CITY OF SEASIDE STAFF REPORT

To: Seaside Planning Commission
From: Planning Director, Kevin Cupples
Date: March 1, 2016
Applicant: Mike Morgan, P.O. Box 132, Cannon Beach, OR 97110
Owner: David & Candace Remer, 292 1st Avenue #PHB, Seattle, WA 98121
Location: 2323 S Roosevelt; T6-R10-28AC-TL#300
Subject: Highway Overlay Zone 16-004HOZ, Convert Former Union 76 Gas Station & Establish a New Restaurant

**PROPOSED LAND USE APPLICATION
RUBY'S GRILL AT 2323 S. ROOSEVELT DRIVE
HIGHWAY 101 OVERLAY ZONE Section 3.400**

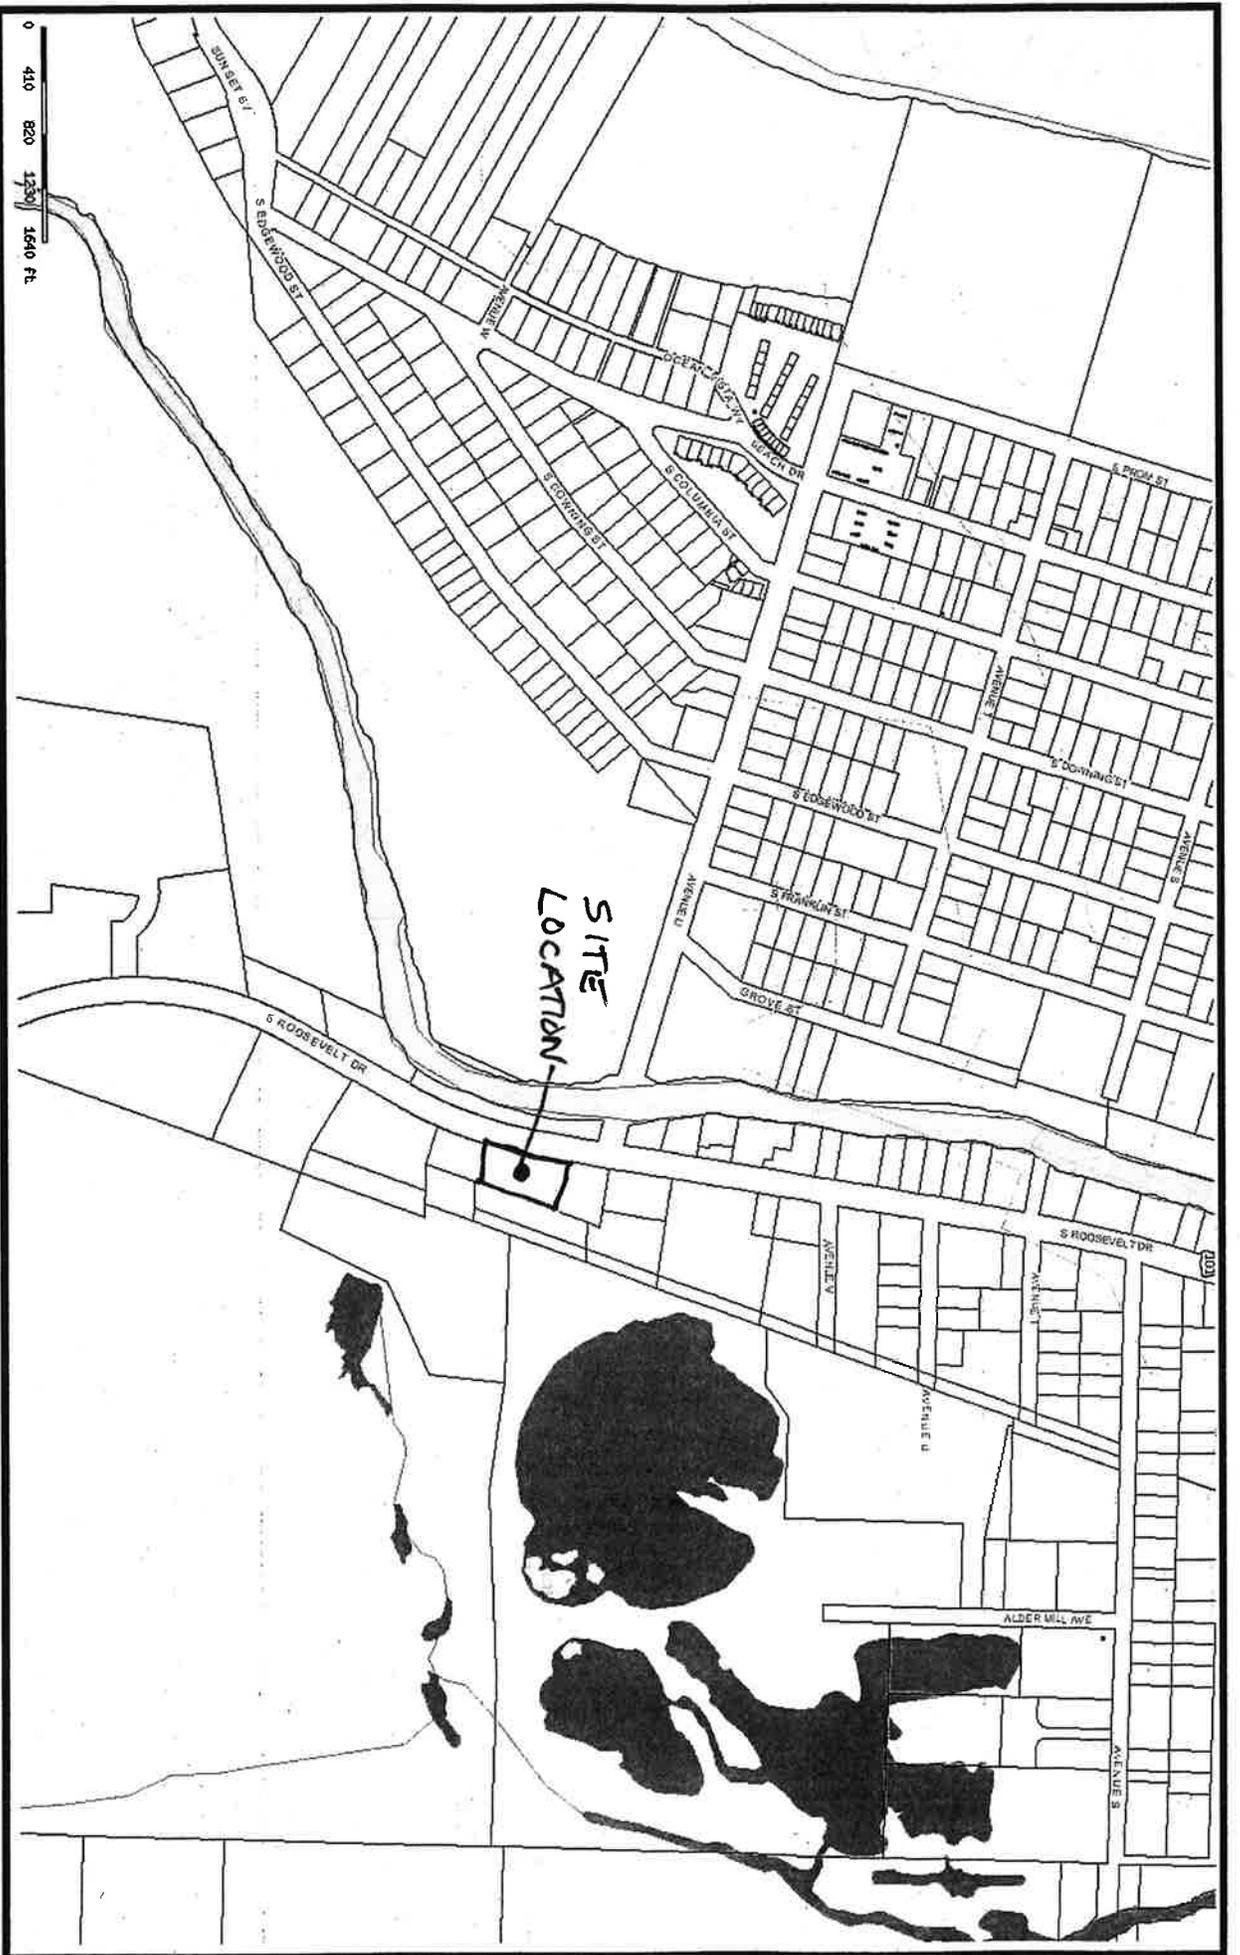
- A trash enclosure will be provided on the north side of the building.
2. Staff is unclear if the applicant will be modifying the lights under the canopy. Existing lights are not required to meet the outdoor lighting standards unless new fixtures are proposed. The existing lights under the canopy are dark sky compliant; however, they would not conform to the outdoor lighting standards based on staff's assumption of output from the translucent coverers.

3. The ordinance calls for building accesses to be located adjacent to the highway within 10 of the front property line and also calls for parking to not be located between the building and the highway. In this case, the building and surfaced areas used for parking already exist and the applicant will not be required to meet the new standards for the existing site development.

4. The restaurant customer accessible area is approximately 1,400 sq. ft. and the parking will allow for the use with up to 3 employees. If the seating area is reduced to 1,350 sq. ft., up to four employees would be allowed.
5. The short term bike parking is intended to be closer to the entrance to the building such that it is no further than the closest car space to the front door. This space is not identified on the applicant's site plan but could be located anywhere along the fronting portion of the building.

Condition 1: All of the proposed exterior lighting will meet the outdoor lighting standards except for the existing canopy lights unless the fixtures are changed or they are specifically required to meet the standard by the Planning Commission based on a condition of approval.

Condition 2: The final development plan must incorporate provisions for short term bike parking in accordance with the standards adopted under Seaside's TSP. These will be approved by the Planning Director.

Condition 3: Minor modifications to the applicant's proposed plan must be reviewed and approved by the Planning Director. These could be required in order to comply with other code issues applicable to the request or reduce impacts to the neighboring property. Any major changes or conflicts over a proposed modification will be reviewed with the Planning Commission prior to the approval of any development permits.
